DECISION OF THE PLANNING ADMINISTRATOR

**CLASS 3 SITE PLAN REVIEW / CLASS 2 ADJUSTMENT / TREE VARIANCE
CASE NO.: SPR-ADJ-TRV25-01**

SUMMARY: A proposal for a building addition, parking lot modification, and change of use to warehousing and distribution and office.

The property is approximately 2.28 acres in size, zoned IC (Industrial Commercial), and located at 2065 Madrona Avenue SE (Marion County Assessors Map and Tax Lot number: 083W02AC / 01300).

1 SITE PLAN - PROPOSED
 A0.3 SCALE: 1/32" = 1'-0"

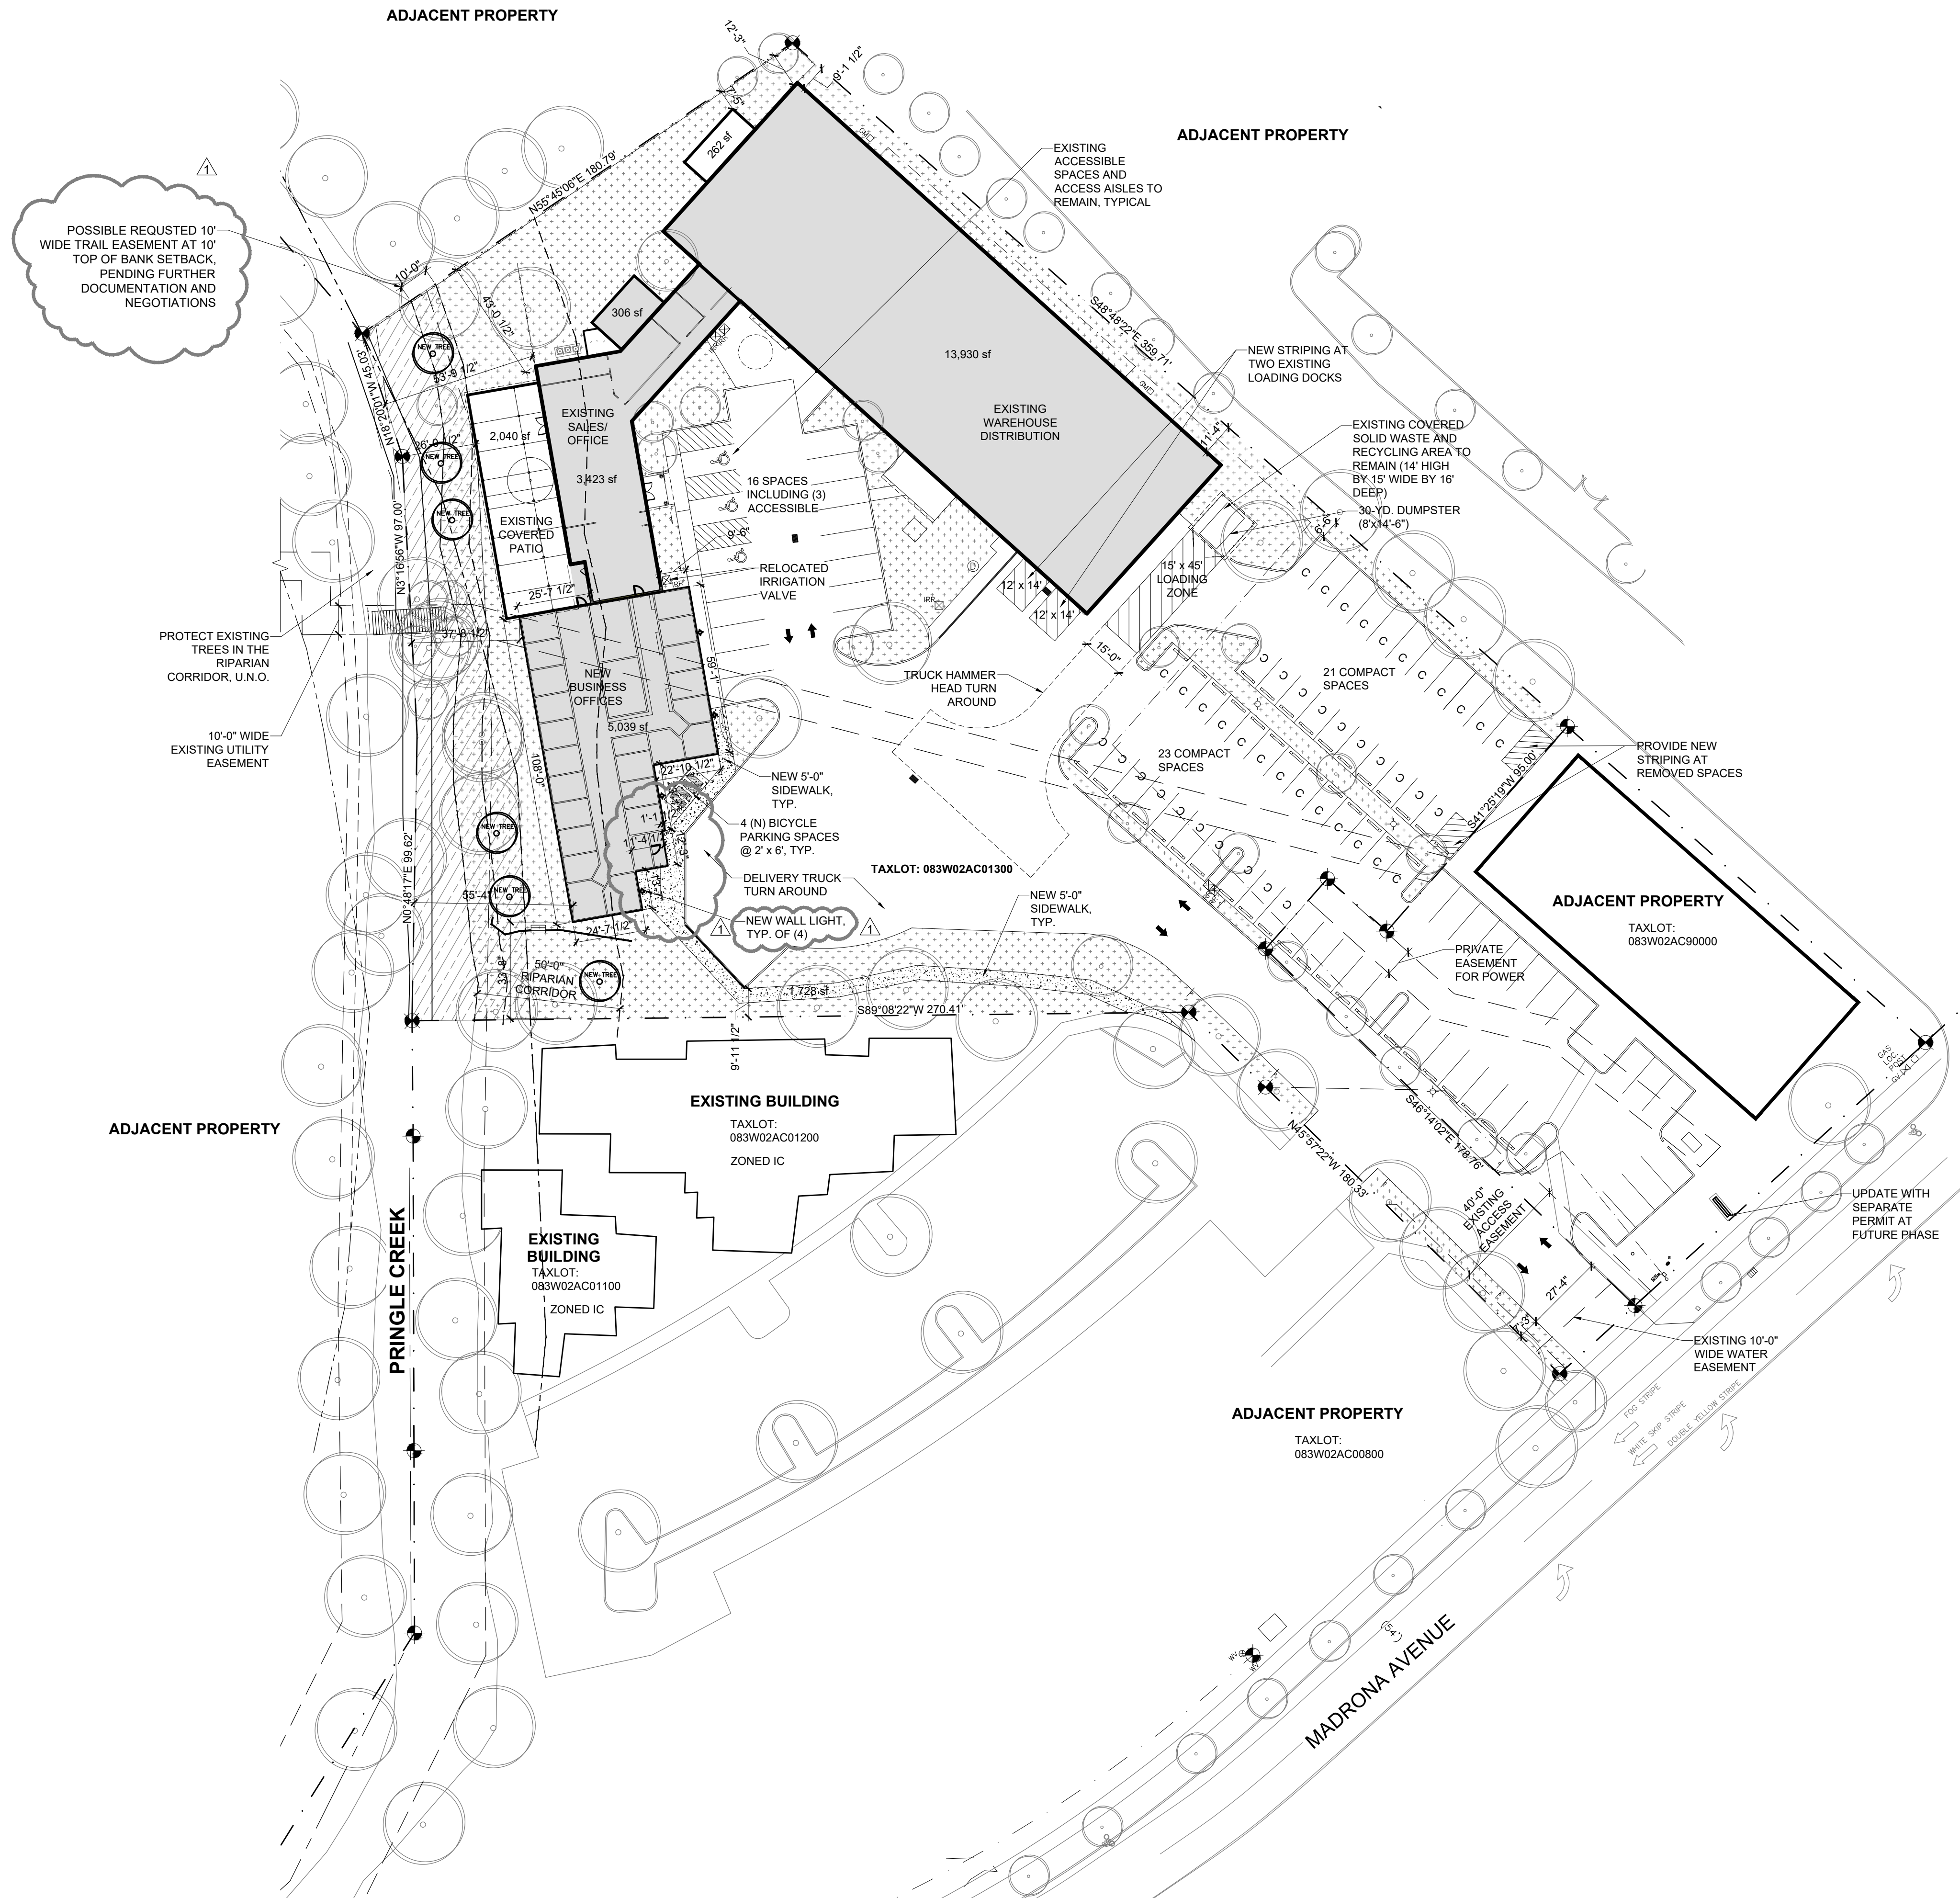
Finding: The building addition and parking lot modifications are limited to the southern and western portions of the property. As proposed, the modified vehicle use area is setback approximately 12 feet from the IC zoned property to the south, and setback approximately 100 feet from the RS zoned property to the west, meeting the standard. The building expansion is approximately 34 feet from the IC zoned property to the south, and setback approximately 42 feet from the RS zoned property to the west, meeting the standard. The applicant is requesting to eliminate the requirement of a fence along the western property line, which is addressed below in Section 7.

Finding: The applicant's plans indicate pedestrian access is provided from the proposed development to the street via the proposed pedestrian path, which connects to the existing pedestrian path on the abutting property. Therefore, this standard is met.

Finding: The applicant's plans indicate the proposed pedestrian connection is at least five feet in width; however, the plans do not demonstrate visual differentiation pursuant to SRC 800.065(b)(1)(B). The pedestrian connection to Madrona Avenue SE crosses a driveway from the flag lot accessway to the office complex in the southwest portion of the development site. No visual differentiation for this driveway crossing is shown on the site plans; therefore, to ensure that the proposed pedestrian walkway meets the design and material standards at the time of building permit, the following condition applies:

Finding: The building addition has approximately 108 linear feet adjacent to the western property line abutting the RS zone. Therefore, the western side of the addition requires 162 plant units for the side property setback ($(30 \times 108) / 20 = 162$). As proposed, on the western side of the addition and within the setback there are: eight existing mature trees (120PU), two new trees (20PU), and approximately 3,300 square feet of ground cover from the top of bank (66PU) for an estimated total of 206 plant units.

Finding: There is an existing private sanitary sewer main serving adjacent property (Marion County Tax Lot No. 083W02AC / 90000) that crosses over the subject property in an easement. Dedication of this easement was originally required through a previous partition of the subject property (Case No. PAR-SPR-ADJ15-08). The applicant’s Preliminary Utility Plan shows the building addition will be placed over this existing private sewer main and easement.

The site plans indicate that the proposed addition is located more than 35 feet from the residentially zoned property, which exceeds the minimum zone-to-zone setback required in Table 551-4 of SRC 551.010(b). The existing vegetation acts as a natural landscape barrier, and most of the residential properties on the other side of the creek have existing fences on their property, providing the same screening function beyond the existing natural barrier. Construction of a fence or wall as required would also result in additional impact to the Riparian Corridor.

The provided site plans identify a total of 53 trees on the property with 12 proposed to be removed. Of the trees proposed for removal, four trees with a dbh of a least ten inches are within the Riparian Corridor. The applicant is requesting Tree Variances to remove two Japanese Maple trees with a dbh of ten inches, one Hazel tree with a dbh of 11 inches, one Spruce tree with a dbh of 13 inches, and additional trees considered riparian vegetation under 10 inches in dbh to develop the property.

Condition 1: At the time of building permit review, a Landscape Plan must be provided demonstrating that a minimum of 15 percent of the development site (approximately 34,107 square feet) is landscaped with Type A landscaping.

Condition 4: Prior to building permit issuance, the applicant shall verify that the existing private sewer main that conflicts with the proposed building addition complies

Condition 5: The adjusted pedestrian connectivity standards, as approved in this zoning adjustment, shall only apply to the specific development proposal shown in the attached site plan. Any future development, beyond what is shown in the attached site plan, shall conform to all applicable development requirements, unless adjusted through a future land use action.

Condition 6: Altered Riparian Corridor areas that can be reasonably restored shall be restored with native vegetation and trees specified in the City of Salem Tree and Vegetation Technical Manual. Species of trees and vegetation will be verified on the submitted Landscaping Plan.
